SERVICE

1024

Induction Airbox Air Valve Bushing Improvement

PA-28-181 Archer III

Fig. 1

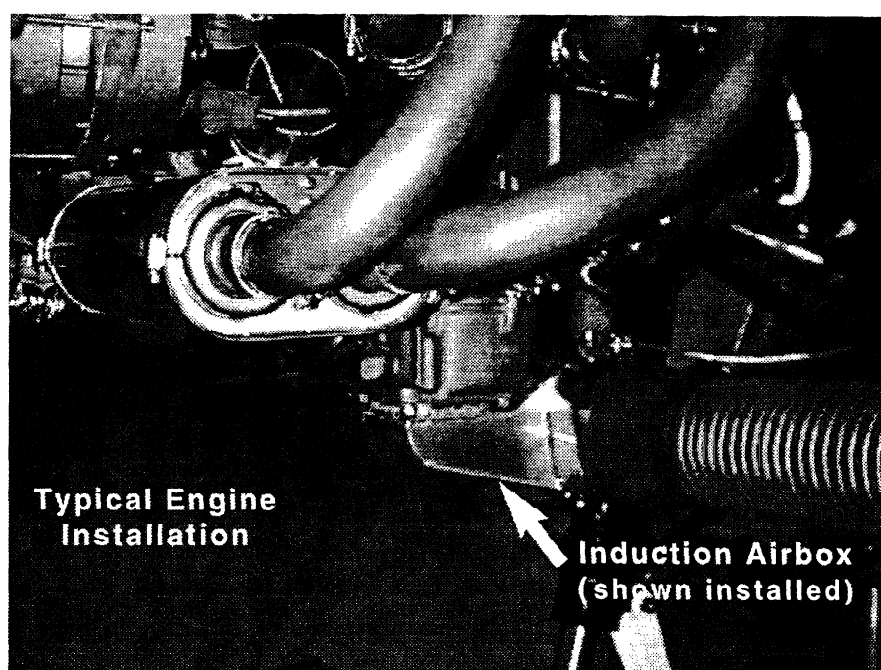
It has been discovered that the bushings and grommets which support the induction airbox air valve are wearing quickly necessitating early repair. This condition has been remedied by an improved design of the bushings and replacement of the existing induction airbox air valve. Left uncorrected, this condition over time may allow the induction airbox air valve to come loose and wear into the airbox housing, which may require expensive repairs or airbox replacement.

1. Install the Induction Airbox Modification kit, Piper Part Number, 766-666. Only one kit is required per aircraft. All of the necessary instructions and materials for successful modification of the induction airbox are contained in the kit. See Fig. 1 & 2 for reference.
2. Perform an engine ground run per the appropriate chapter of the applicable Maintenance Manual to assure engine performance. Correct as required.
3. Make an appropriate logbook entry indicating compliance with this Service Letter.
